## **Annex B**

### **LVIA Viewpoint Analysis**

**Landscape Proof of Evidence on behalf of**

The development of a Battery Energy Storage System (BESS), comprising a 500 megawatt (MW) battery storage facility with associated infrastructure, access and landscaping, with a connection into the Culham Jet National Grid substation.

**Figure B3: Appeal Scheme Montage Vignette (Year 10)**

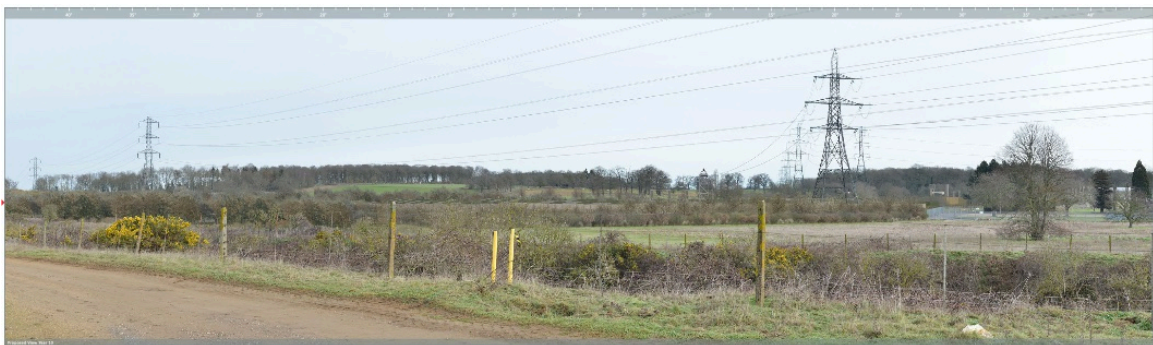
- B17 If consented with the **Appeal Scheme** proposals, the proposed BESS container aspect of the development would extend across a 60-degree wide proportion of this view. The grid connection part would extend farther to the south-east.

- B18 The 4m high perimeter would dominate the foreground of the view for at least 5 years and the enclosure created by the appeal proposals would reduce the rurality and the open character that is key to the appreciation of the Parkland, Parkland setting and Green Belt in views from this location. The appeal scheme montage indicates that by year 10 most of the BESS storage container parts of the scheme would be fully screened. This is somewhat greater than would be anticipated using the growth models agreed with the LPA officers. The development post-planting at c year 15 would still be visible on the viewer-side of the fence when looking north-east. The connection element of the scheme is substantial and in combination with the tower would add to the magnitude of change of view.

- B19 The LVIA assessed that the receptor value is high, susceptibility low due to the presence of the Campus and electrical infrastructure and overall sensitivity medium. The LVIA author concluded that at **year 1 with mitigation** the visual effect would be **Moderate – Major adverse winter and summer**. The assessor notes that mitigation includes: Landforming (bund no linger part of the appeal scheme), acoustic fence, tree, scrub and hedge planting along the western and southern boundaries.
- B20 The LVIA assessed that at **year 10** with mitigation the visual effect would be assessed that overall, visual effects for footpath users on the Oxfordshire Green Belt Way will be **minor adverse in both winter and summer**.

- B21 The LVIA assessed that at **year 20** with mitigation the visual effect would be **minor beneficial in winter and summer**.
- B22 I have assessed that the at **year 1 with mitigation** the magnitude of change here would be high, and the users of the Oxfordshire Green Belt Way long-distance footpath and future residents of the STRAT 9 allocation are of high sensitivity, bringing about a **substantial (or major) adverse** effect.

- B23 With mitigation at **15 years** post-development the magnitude would remain **high**. The mitigation would only have a minimal effect on the assimilation of the development into the landscape. Many elements of the proposed mitigation would be at odds with both the rural landscape character, the openness of the Green Belt character (perceptually, visually and spatially) and the parkland character (as articulated in detail by Ms Sasha Berezina in her proof of evidence).

- B24 The discordant patterns and impact on openness are articulated in detail in my main proof of evidence. The mitigation planting would eventually screen the appeal scheme and visually distract from the dramatic open sweep of grassland up to the parkland and wooded skyline. Landform and parkland edge character would no longer be seen as the main visible characteristics of this view when seen from the Oxfordshire Green Belt way in this part of the landscape.

Figure B4: Baseline Viewpoint 6 Vignette

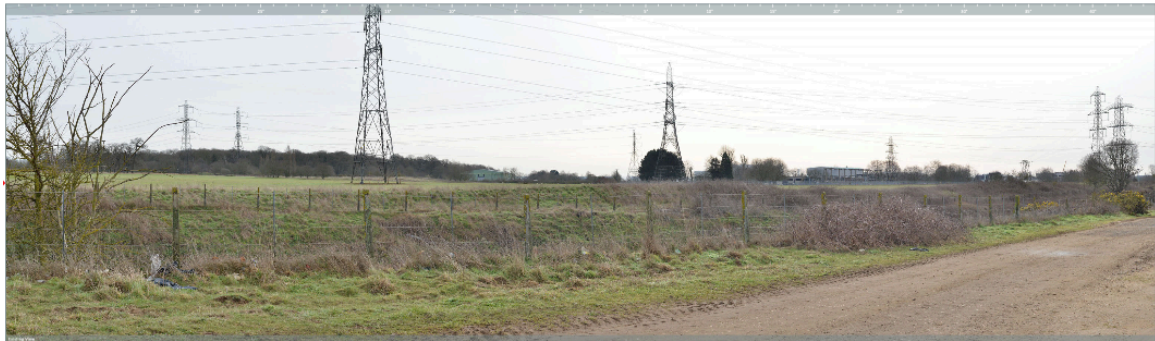
- B26 Looking east from the Oxfordshire Green Belt Way towards the site 50m distant, and landform dropping slightly to c 64m and the view becoming less open due to the adjacent level railway embankments leading towards the Brunell river bridge. The viewer is now broadly eye-level with the land of the proposed development.

- B27 The current (baseline) panoramic view shows layers of trees and hedges forming a relatively shallow horizon with a wooded skyline. The railway line is in cutting and in the foreground of the view, beyond the adjacent wire fence. In winter, bare leaf conditions, the railway corridor is seen with minimal vegetation, and in summer there is a thin strip of intermittent vegetation on the upper slopes of the railway sidings in cut and adjacent to the fence. This does not amount to a hedge.

- B28 The landscape scale is recognised as being broad-scale and framed by skyline woodland. The lines of pylons running through the landscape are readily observed, but when walking this route are less of a detracting than suggested by the LVIA author or recorded in this static view. To the south-east of the appeal site the edge of the more industrial landscape around and forming the Culham Campus is evident, with metal security fencing and the presence of campus-style tree planting that contrast with the rural landscape and parkland character.

- B29 If consented with the **Appeal Scheme** proposals, the proposed development would extend across a wide proportion of this view. The 4m high perimeter would dominate the foreground of the view.

- B30 The full set of buildings would be seen on the relative to the viewer who is slightly lower in the landscape in this view, raised landscape platform with the 4m high fencing dominating the view during construction and at year 1. Movement of vehicles and lighting would be evident across a broad angle of view during construction. The tops of woodland and trees on the skyline would be seen behind the proposed containers and fence at this elevation however on travelling further north and downhill from this viewing position towards the Thames valley, the whole of the skyline would be taken up by the proposed development. The mitigation planting would eventually screen the appeal scheme and the skyline. Landform and parkland edge character would no longer be viewed from the Oxfordshire Green Belt way in this part of the landscape. These discordant patterns and impact on openness are articulated in detail in my main proof of evidence.

**Figure B5: Viewpoint 6 Appeal Scheme Year 10 Montage Vignette**

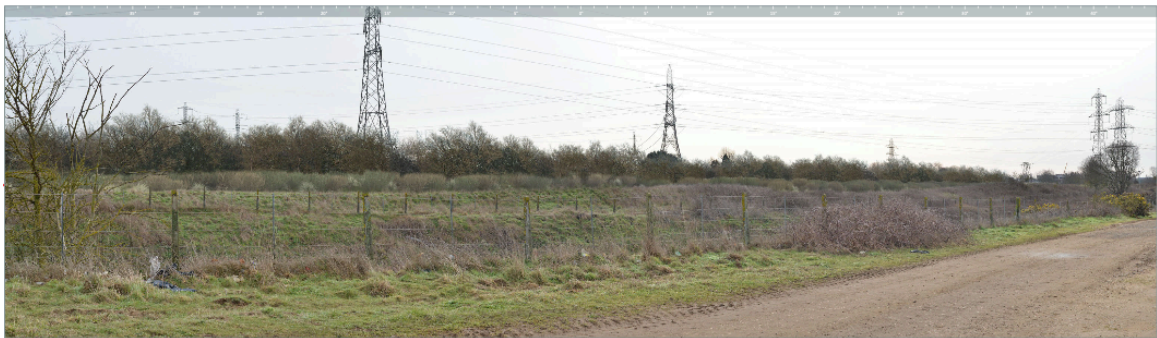
- B32 The LVIA assessed that the receptor value is high, susceptibility medium and overall sensitivity medium-high. The LVIA author concluded that at **year 1 with mitigation** the visual effect would be **Moderate adverse winter and summer**. On the basis of the LVIA methodology (**CD 1.1.18**) this means the magnitude of change is assumed to be medium-low. Medium to low magnitude of change is articulated in the LVIA methodology as being between a development typically being seen in views for the long or medium term where

- B33 The assessor notes that mitigation includes: Landforming (bund no longer part of the appeal scheme), tree, scrub and hedge planting along the western and southern boundaries.

- B34 The LVIA assessed that at **year 10** with mitigation the visual effect would be assessed that overall, visual effects for footpath users on the Oxfordshire Green Belt Way will be **minor adverse in both winter and summer**.

- B35 The LVIA assessed that at year 20 with mitigation the visual effect would be **minor beneficial in winter and summer**.
- B36 I have assessed that the magnitude of change here would be high, equating to the LVIA Table 9 methodology whereby: *Typically this would be where a development would be obvious to the casual viewer, seen in close proximity with a large proportion of the view affected with little or no filtering or backgrounding and there would be a great scale of change from the present situation for the long or medium-term.*

- B37 The users of the Oxfordshire Green Belt Way long-distance footpath and future residents of the STRAT 9 allocation are of high sensitivity, bringing about a **substantial (major) adverse** effect. With mitigation at 15 years post-development the magnitude would remain high. The mitigation would only have a minimal effect on the assimilation of the development into the landscape.
